CHABOT- LAS POSITAS COMMUNITY COLLEGE DISTRICT

Addendum No. 1 INVITATION FOR BID No. 08-10 Demolition of Buildings 400/600/700, Chabot College

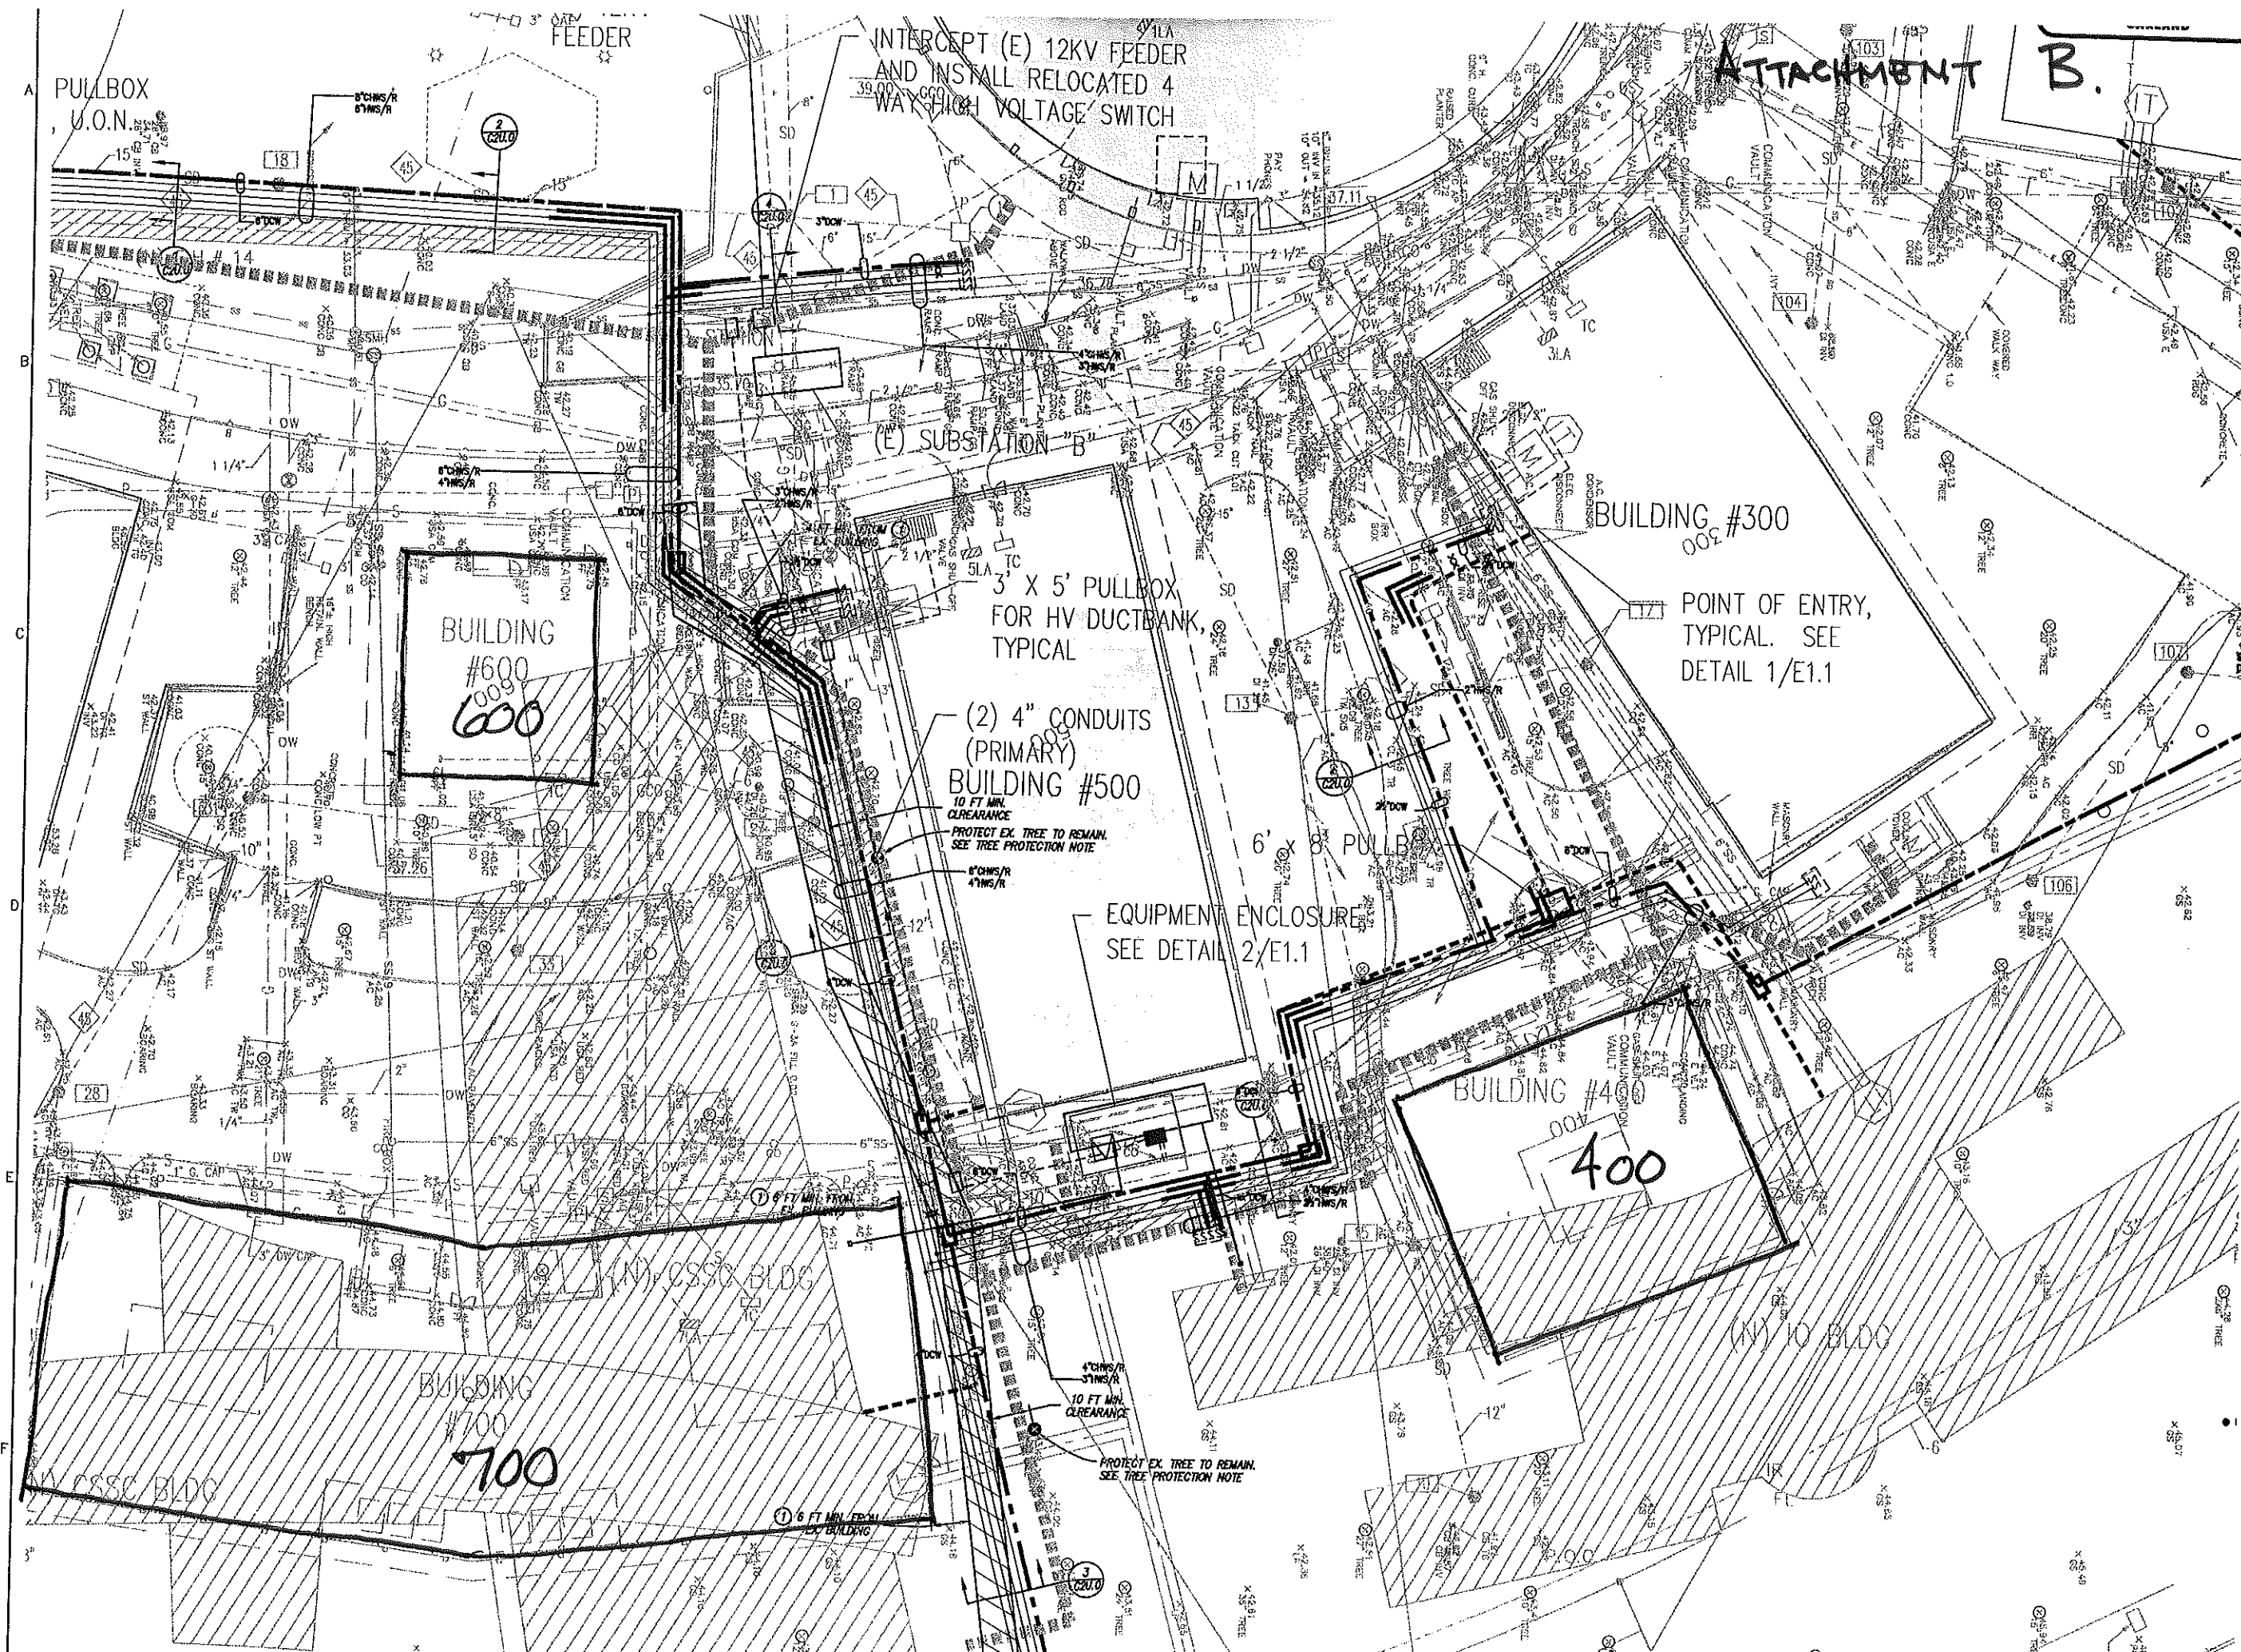
<p>Removal of conduit beyond 5' is not required.</p> <p>Work shall be performed by Licensed Telecom & Electrical Contractors (tBP)</p>
9	RFI # 9	<p>Question: There are two very time consuming items that are in the scope of work: a) sealants between concrete panels around doors and windows b) black moisture barrier on perimeter concrete walls.</p> <p>Because of the coordination between abatement and demolition, contractors perform item A and because item B will need to be a stand alone abatement scope, the schedule does not seem realistic. If the schedule is not revised it probably will be necessary to work multiple shifts and maybe weekends. Is this acceptable?</p> <p>Answer: Item b) does not exist - this is explained elsewhere in the addendum Item a) exists but will not present as labor intense a project as previously thought - see remainder of addendum</p> <p>Yes - if necessary, any work hours may be worked provided noise and light ordinances are not violated. (HMS)</p>
